April 6, 2012

Cogentrix Quail Brush Generation Project – Docket Number 11-AFC-3, Data Request Responses to Set 2

Transmission System Engineering

ATTACHMENT K
PRE- AND POST-PROJECT ELECTRICAL ONE-LINE DIAGRAM

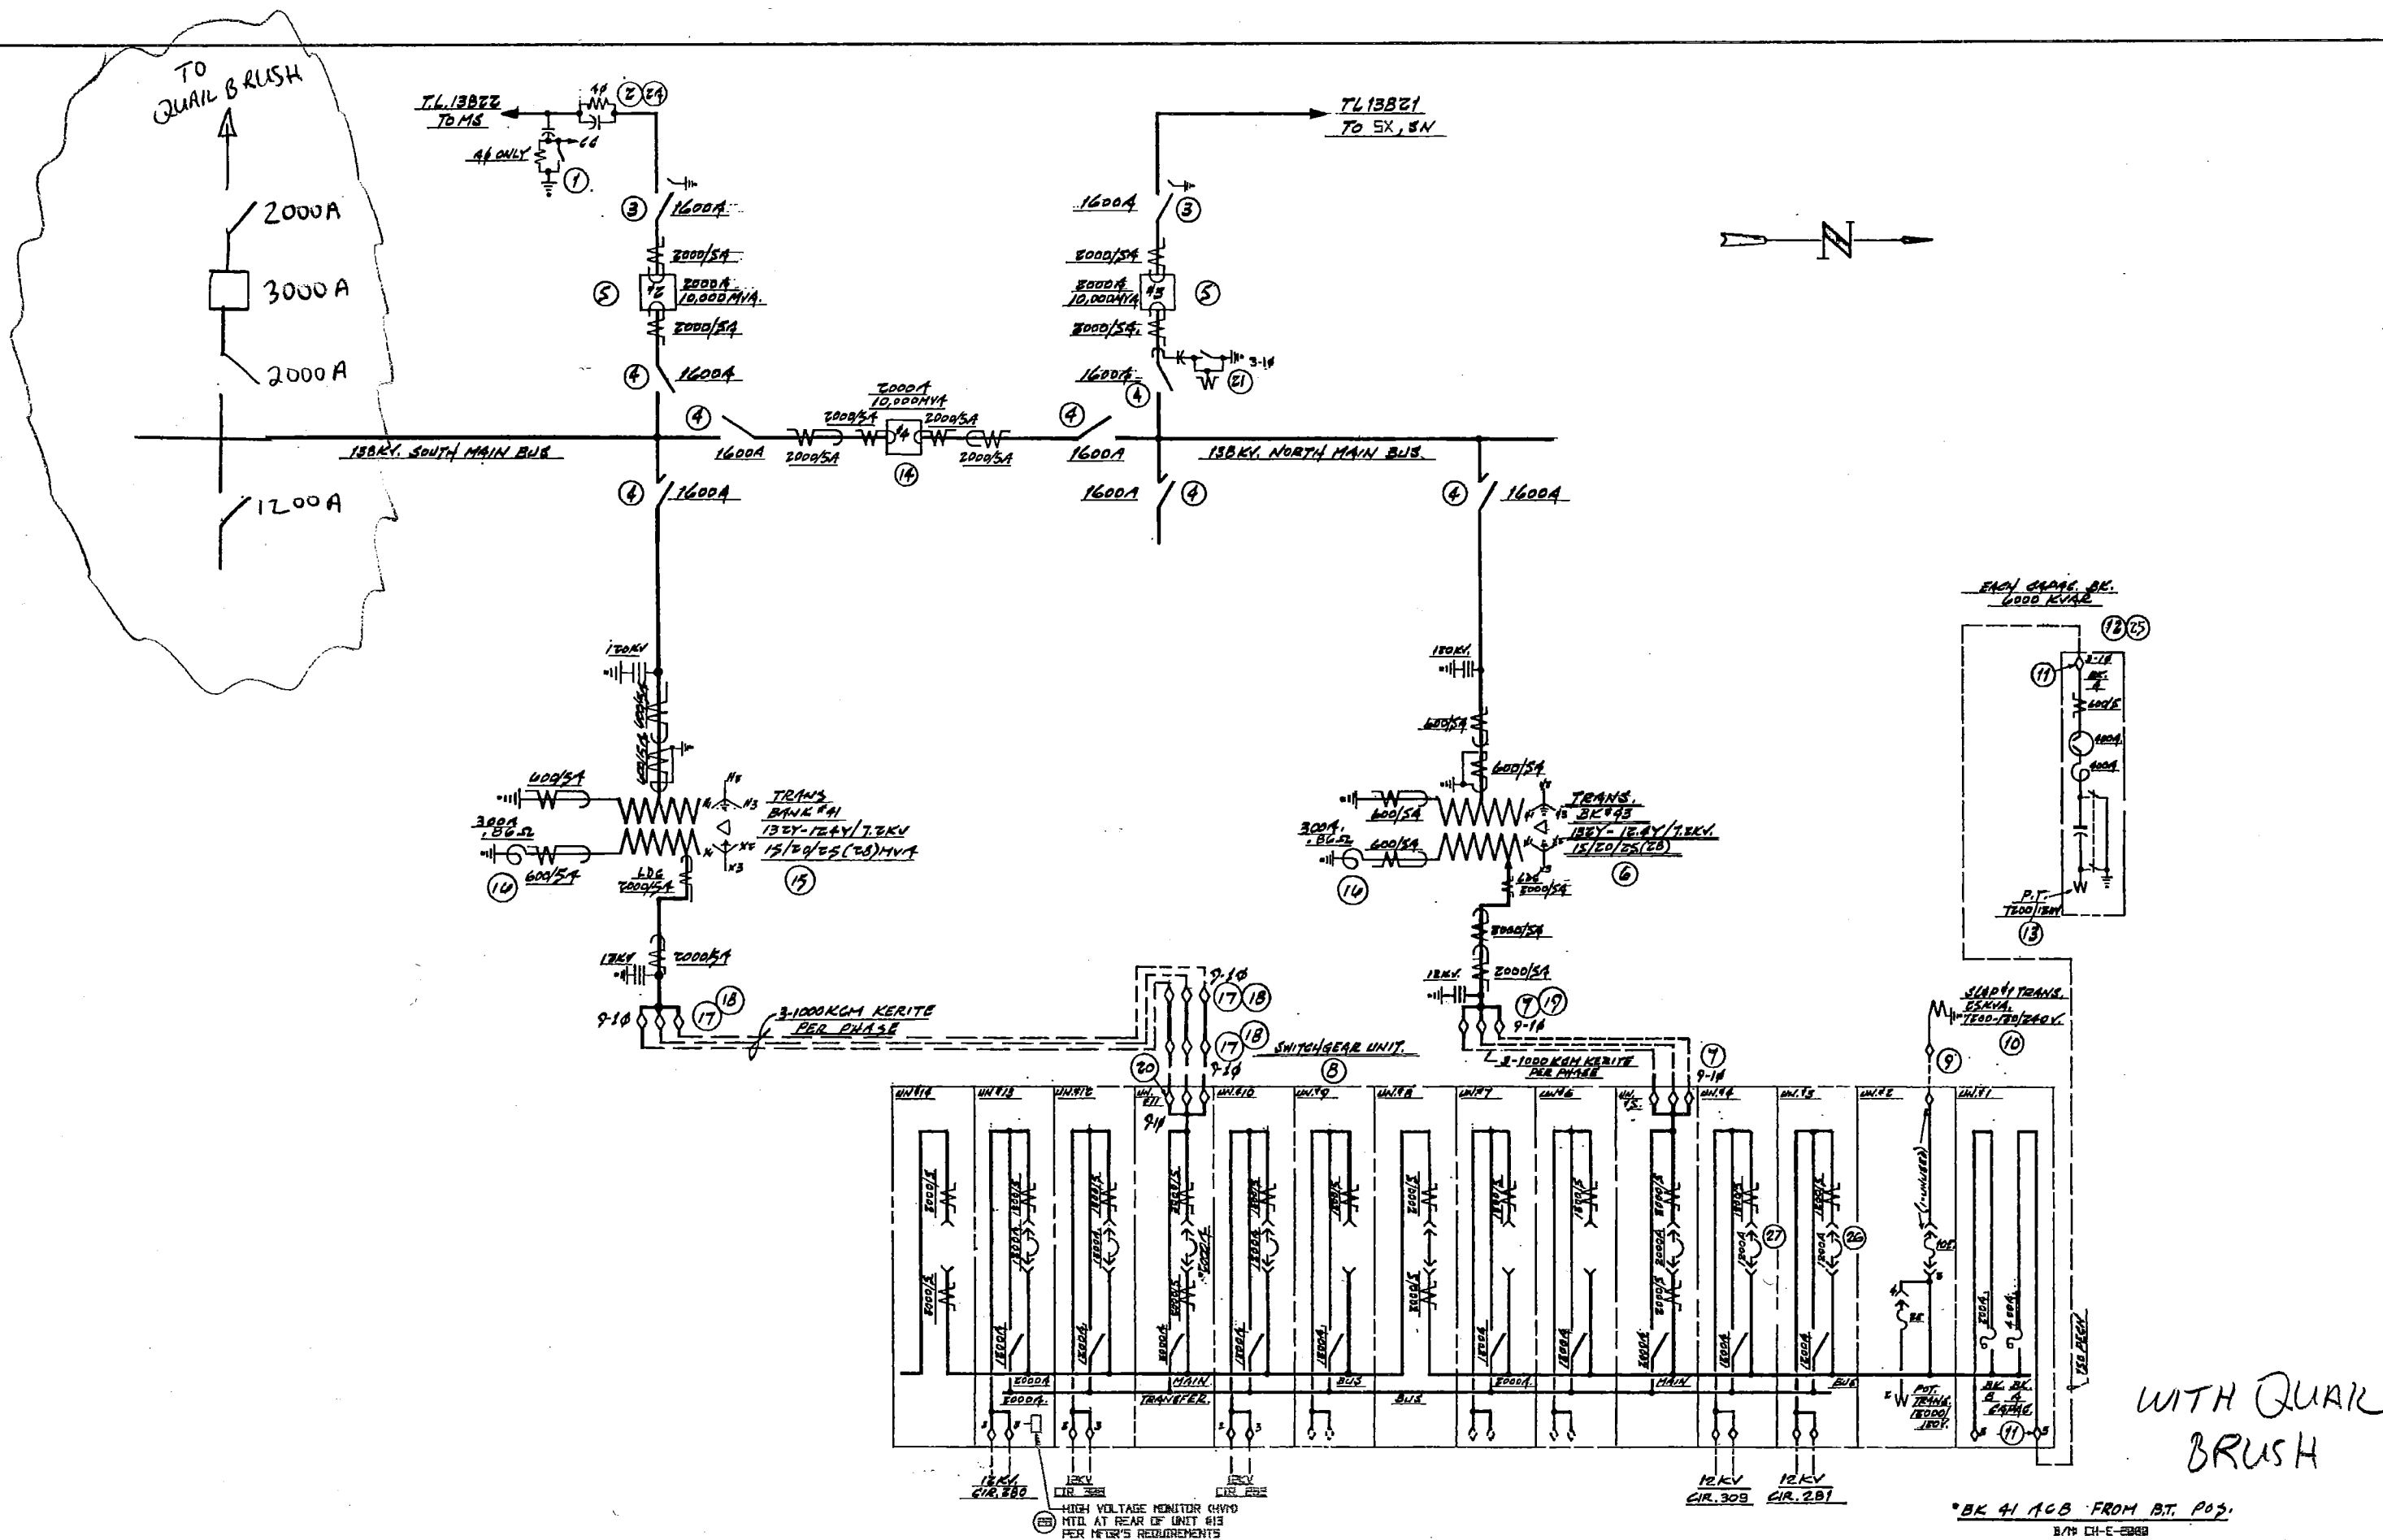
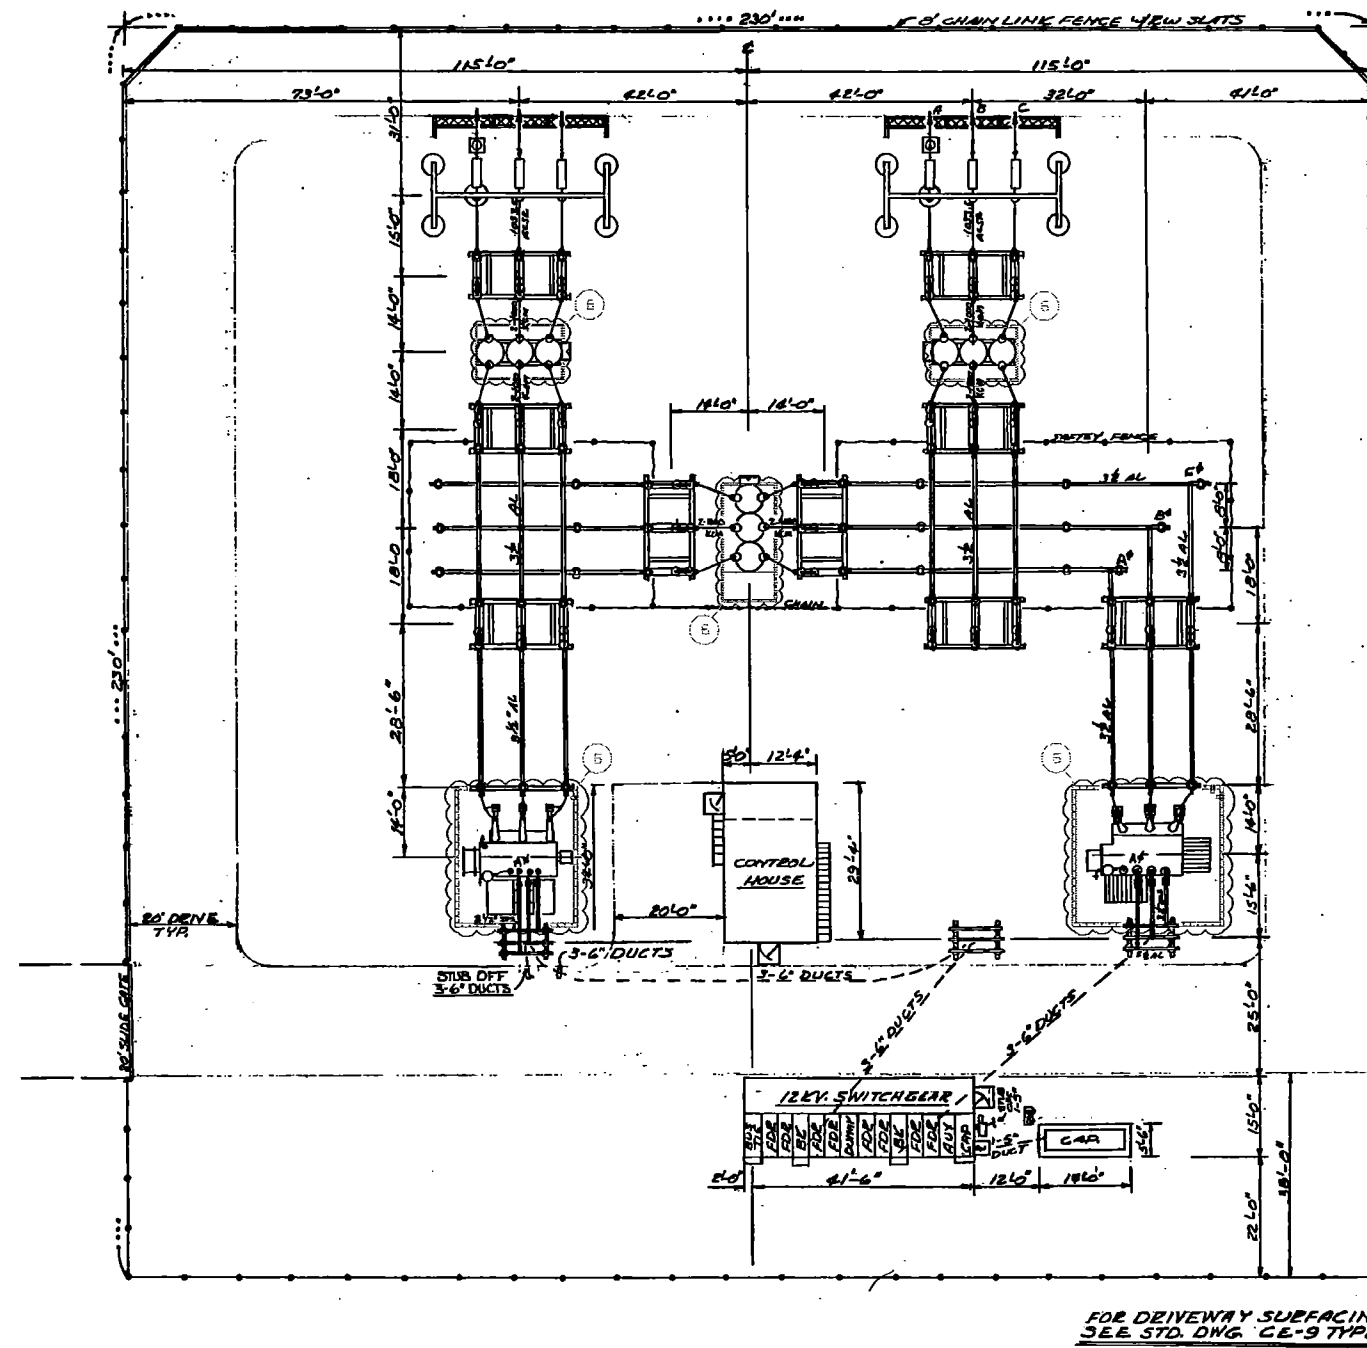
63. Please provide pre and post-project electrical one-line diagrams of the SDG&E Carlton Hills 138 kV substation with all transmission outlets showing the proposed modifications in the substation for interconnection of the gen tie line along with configuration of buses, breaker, disconnect switches, and their respective sizes and/or ratings.

The pre- and post-Project electrical one-line diagrams of the Carlton Hills 138 kV substation have been provided by SDG&E and are included as Attachment K. The post-Project drawings in Attachment K depict the Preferred route terminating in the empty south bay of the Carlton Hills Substation.

ATTACHMENT L
PRE- AND POST-PROJECT PHYSICAL LAYOUT DRAWINGS

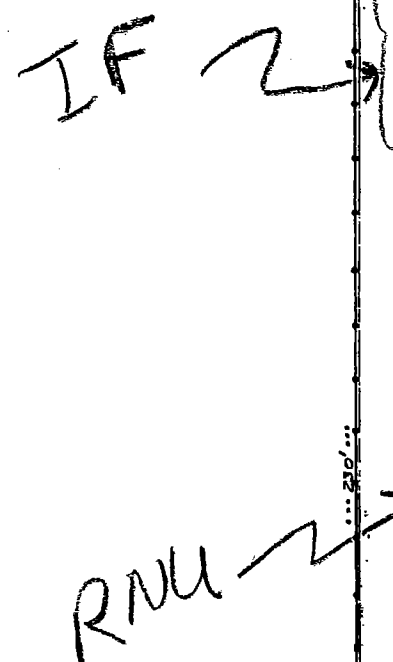
64. Also provide pre and post-project physical layout drawings of the SDG&E Carlton Hills 138 kV substation with all transmission outlets.

Pre-and post-Project physical layout drawings of the Carlton Hills 138 kV Substation have been provided by SDG&E and are attached as Attachment L. The post-Project physical layout (elevation drawing) at the Carlton Hills 138 kV Substation is represented by Section 2-2 on Attachment L. The pre- and post-Project general arrangements of the Carlton Hills 138 kV Substation are included in Attachment K.
